Staff Report

Infill Housing Design Review Committee

File Number: 4-H-21-IH

Location: 1215 Texas Ave. **Parcel ID** 81 | C 016
Zoning: RN-2 (Single-Family Residential Neighborhood)
District: Lonsdale Infill Housing Overlay District

PLOT PLAN FOR LOT 183, ROSEDALE ADDITION TO THE CITY OF KNOXVILLE

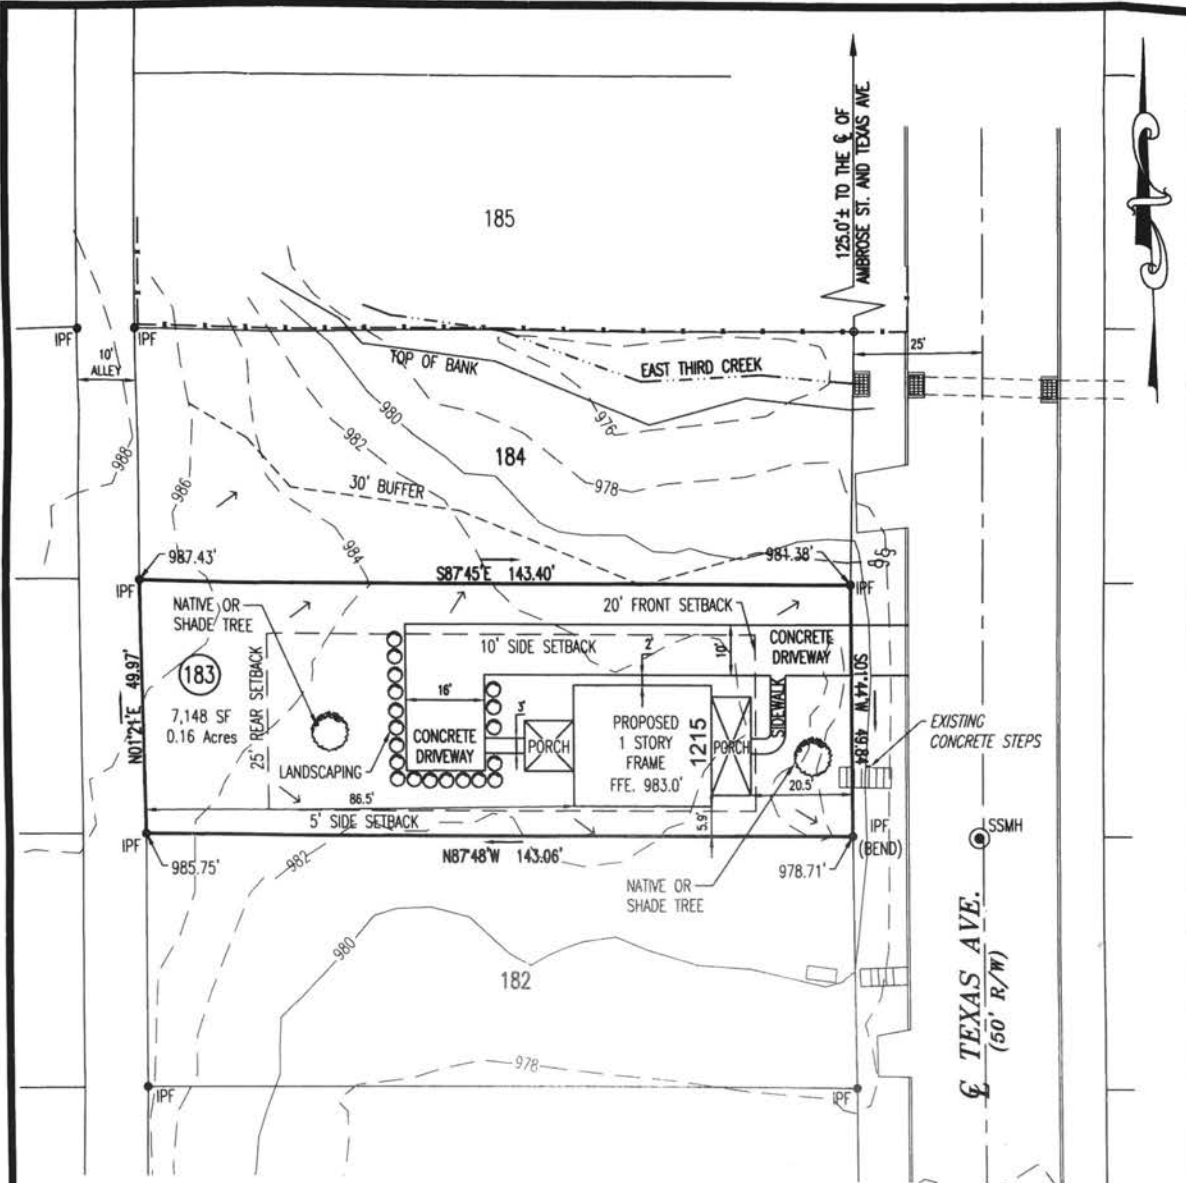
1. The house is proposed with a front setback of 20.5' from the front porch to the property line, and 28.5' to the primary residence. The proposed new construction at adjacent 1219 Texas Avenue will reflect the same setback pattern. The proposed front setback will maintain front yard spaces consistent with the rest of the block.

6. The applicant proposes to extend the driveway off Texas Avenue. While guidelines encourage using operable alleys whenever possible, the alley on the 1200 block of Texas Avenue stops behind 1227 Texas Ave. City Engineering has confirmed the alley is not operable behind 1227 Texas Ave, so access will have to extend off Texas Avenue. The proposed parking meets City Engineering requirements and the Infill Housing guidelines.

7. The site plan shows native shade trees in the façade and rear yards, which meets design guidelines for landscaping. Landscaping is shown to surround the parking pad in the rear.

8. A 10' by 10' rear porch is shown on the site plan but not elevation drawings.

- 1) Parking to meet City Engineering standards;
- 2) Use horizontal lap siding instead of Dutch lap or flush panel siding to reflect historic context;
- 3) Use a foundation height and cladding materials comparable to historic houses on the block;
- 4) Incorporate a zero-step entry and meet City Homemaker accessibility requirements;
- 5) Introduce a variation in the design between 1215 Texas Avenue and 1219 Texas Avenue (4-I-21-IH), with approval by staff.

EXTERIOR
 ELEVATIONS
 WALL
 SECTION

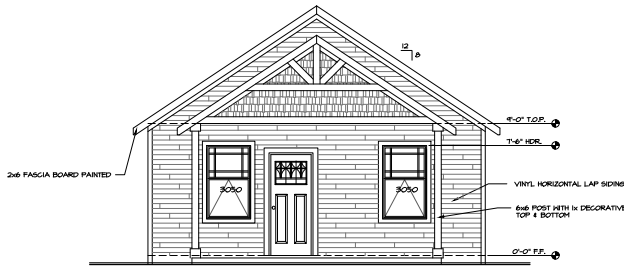
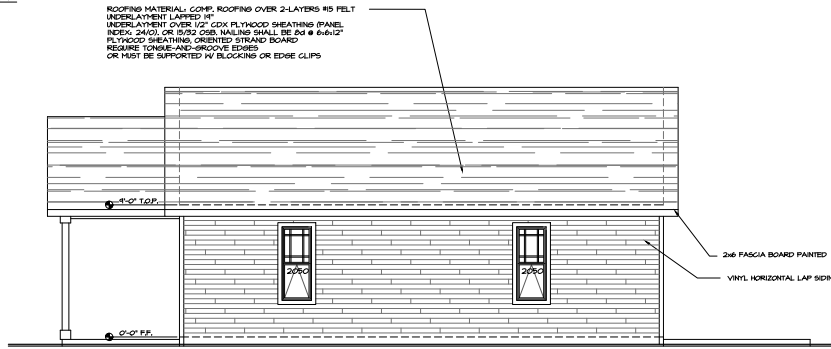
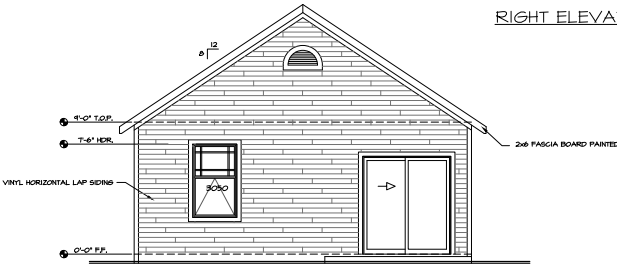
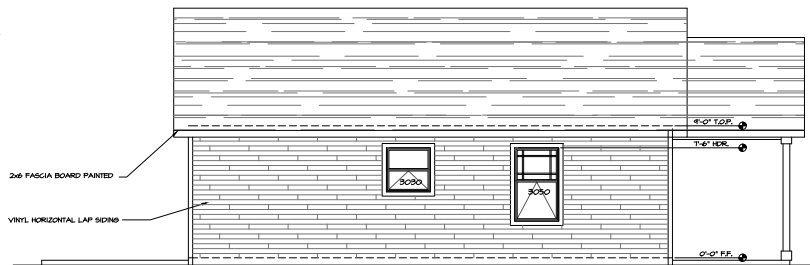
2. The 1200 block of Texas Avenue features a variety of simple housing styles, including several Queen Anne cottages, Minimal Traditionals, and some contemporary infill construction. A one-story, modestly-sized house is somewhat smaller in scale than other houses on the block. A 24' wide façade is smaller than original houses on the block. Foundation height should be verified to reflect heights of original houses in the surrounding blocks.

3. The 8' deep front porch meets the design guidelines for size and placement.
4. Guidelines recommend window and door styles to be comparable to original or historic houses on the block; the revised elevation drawings incorporate double-hung windows with sufficient transparency for a small house. Applicant has noted the final window selections will be one-over-one instead of the Prairie-style muntins shown on the elevation drawings.

5. The proposed roof has an 8/12 pitch, which is sufficiently steep to meet the design guidelines. Horizontal siding also meets the design guidelines; applicant should select a lap siding instead of Dutch lap or flush panel siding to reflect historic context.
